National Fire Protection Association

To: Technical Committee on Single- and Multiple-Station Alarms and Household Signaling Systems
From: Jenny Depew *Administrator, Technical Projects*
Subject: Working Draft of Committee Meeting Output
Date: September 5, 2019

WORKING DRAFT OF COMMITTEE MEETING OUTPUT

Document: NFPA 72
Revision Cycle: A2021
Meeting Date(s): July 22-24, 2019
Committee Activity: Input Stage

Figure A.29.5.3 Four Pulse Temporal Pattern.

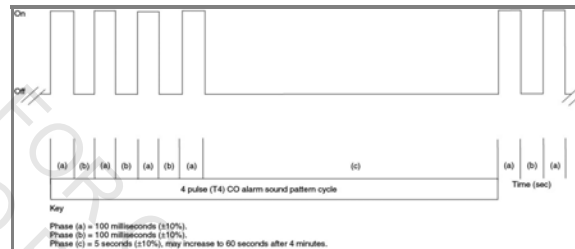
Replace the text of the figure to read as follows: Phase (c) = 5 seconds $\pm 10\%$, should be permitted to increase to 60 seconds ($\pm 10\%$) after 4 minutes.

Committee Statement: The section number is revised to correspond to the correct section in the body of the standard that relates to the four-pulse (T-4) temporal pattern. The text in the figure was revised to follow the NFPA Manual of Style and to correlate with the product standard (UL 2034).

Figure A.29.5.5(b) Temporal Pattern Parameters with 1.5-Second Voice Allowance.

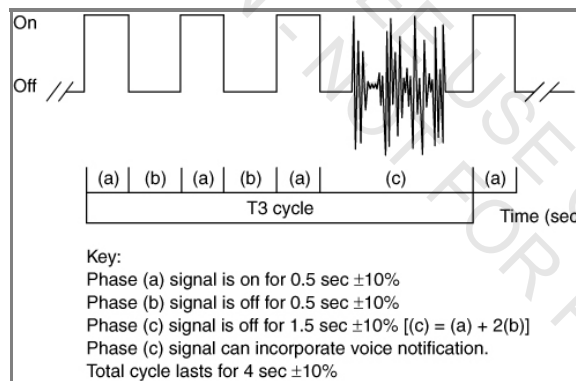
Figure A.29.5.5(b) T3 Temporal Pattern Parameters with 1.5-Second Voice Allowance

Committee Statement: The captions are revised to better identify each figure.

Figure A.29.11.3.4(4)(a) Example of Zone of Exclusion (gray area) Within Typical Residential Kitchen.

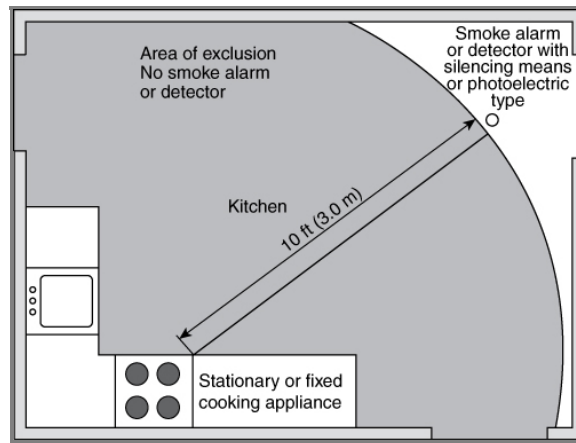
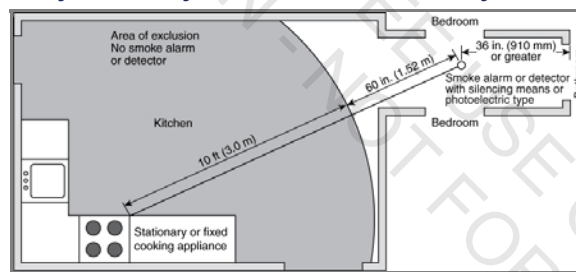
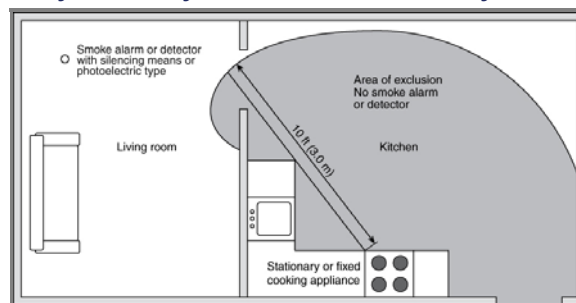
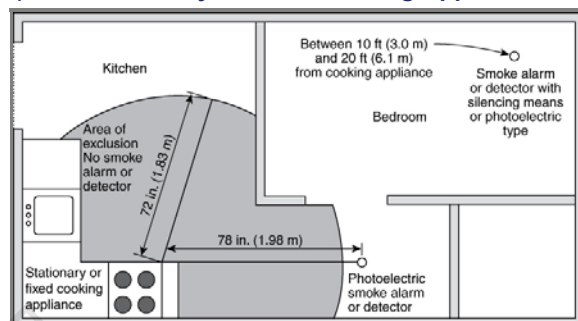
In response to the above noted nuisance alarm studies, the 8th edition of UL 217 and the 7th edition of UL 268 have added a new performance test to help reduce nuisance alarms from normal cooking. This end product performance and listing requirement align with Section 29.11.3.4(6) of this Code. Smoke alarms complying with these UL standards will be Listed "for resistance to common nuisance sources from cooking" and are suitable for installation at distances from cooking appliances outlined in this Code.

Committee Statement: The last paragraph has been added to address alarms listed to the new UL nuisance test. During the transition to new editions of UL 217 and UL 268 guidance on existing technologies is still valid and remains in this Code.
